CASE NO.: C8-2013-0177.0A

SUBDIVISION NAME: Tabrizi Subdivision

ADDRESS OF SUBDIVISION: 4316 Far West Blvd.

MEMORANDUM

Aerial View Impevious Cover On Slopes In Relation to Surrounding Subdivisions

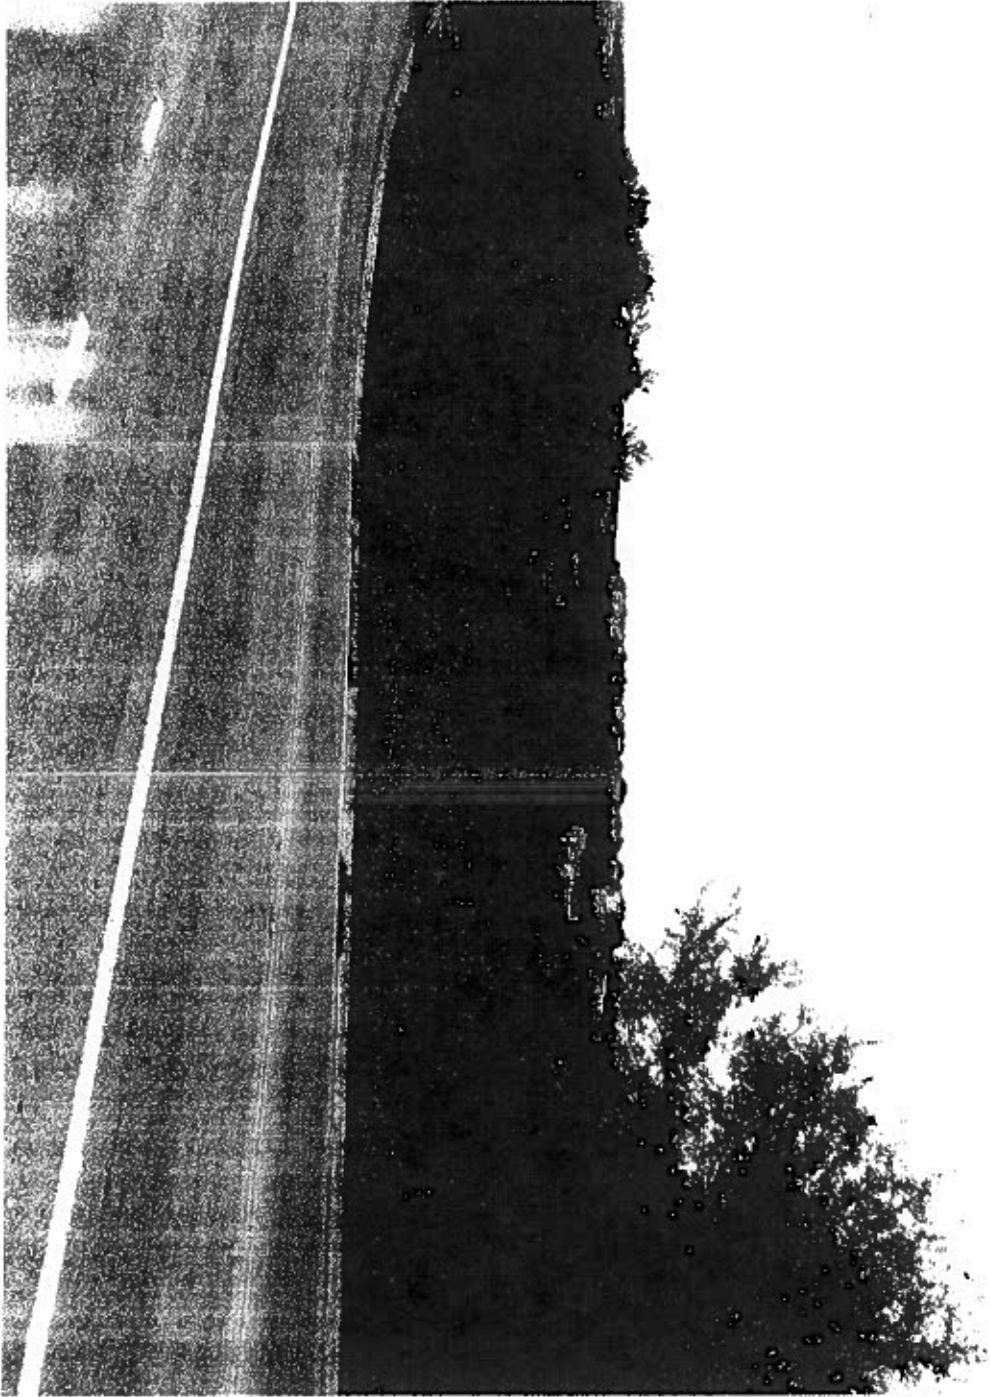
No. This variance has not been granted for other similarly situated single family homes or existing homes in the surrounding adjacent subdivisions. See staff's impervious cover on slopes exhibit Pg. 17 that indicates homes on slopes less than 15%.

No. This variance has not been granted for other similarly situated single family lots with existing homes in the surrounding adjacent subdivisions. See staff's impervious cover on slopes exhibit Pg. 17 that indicates homes on slopes less than 15%.

FIGURE 1
SITE DEVELOPMENT PLAN
0.56-ACRE UNDEVELOPED RESIDENTIAL LOT
4316 FAR WEST BLVD.
AUSTIN, TRAVIS COUNTY, TEXAS 78731

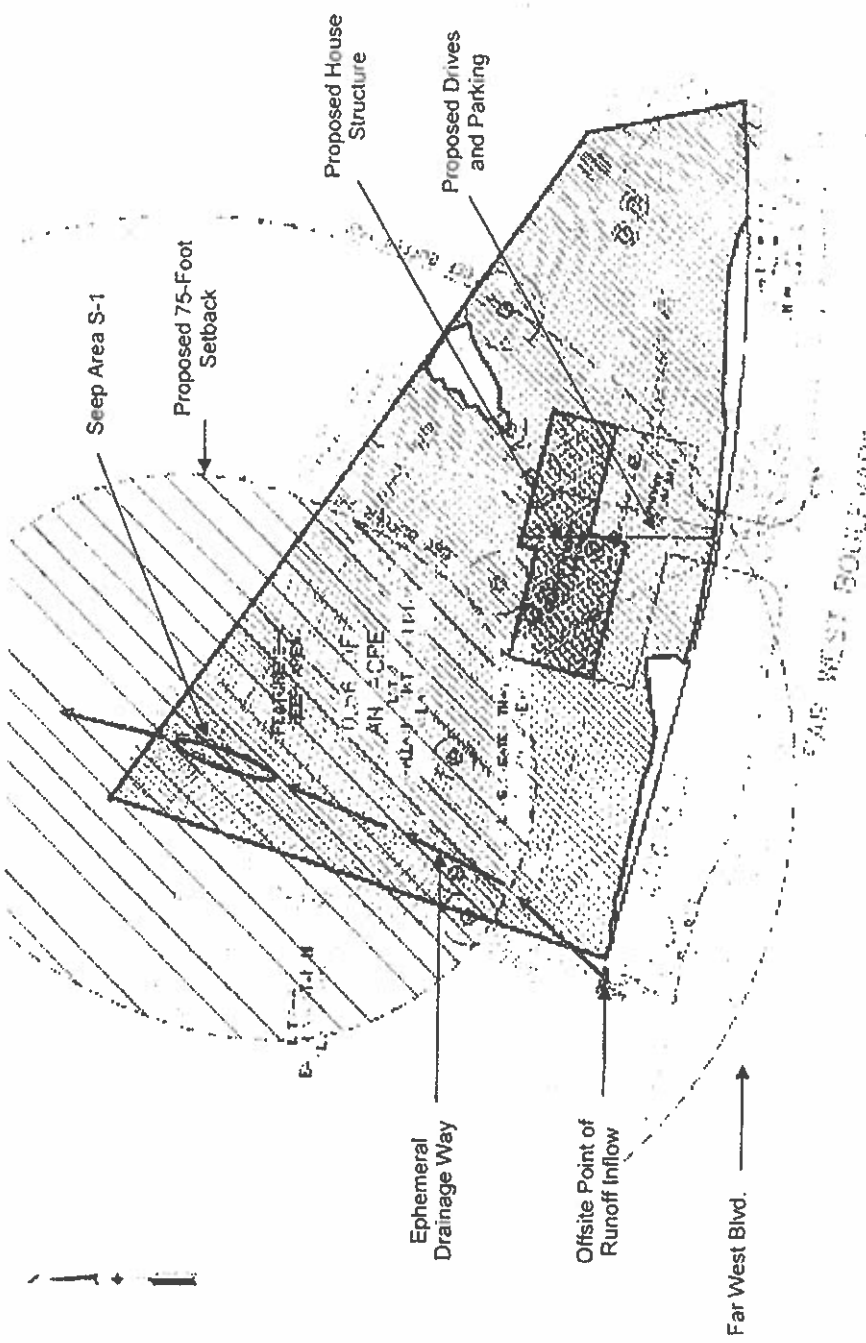
CEF S-1 represents a series of seep conduits along a 20- to 30-foot segment of the onsite ephemeral drainage way (refer to attached Figure 1). The drainage way exhibits high and steep sidewalls and shows characteristics of rapid flow during rain events. The seep area appears to be active following periods of precipitation and inactive during droughts. The seeps were observed active at the time of the site reconnaissance (October, 2013), and the flow/discharge rate was estimated at or less than 0.1 gallons/minute.

The 0.56-acre lot is proposed for development as a single-family residence, including a house structure and driveway that accesses Far West Blvd. (refer to attached Figure 1). Given the extreme topographic slopes over the entire lot, the house structure is proposed to be built aboveground on steel piers, with the front of the structure base at street level and the back (north side) positioned up to approximately 30 feet above ground surface.
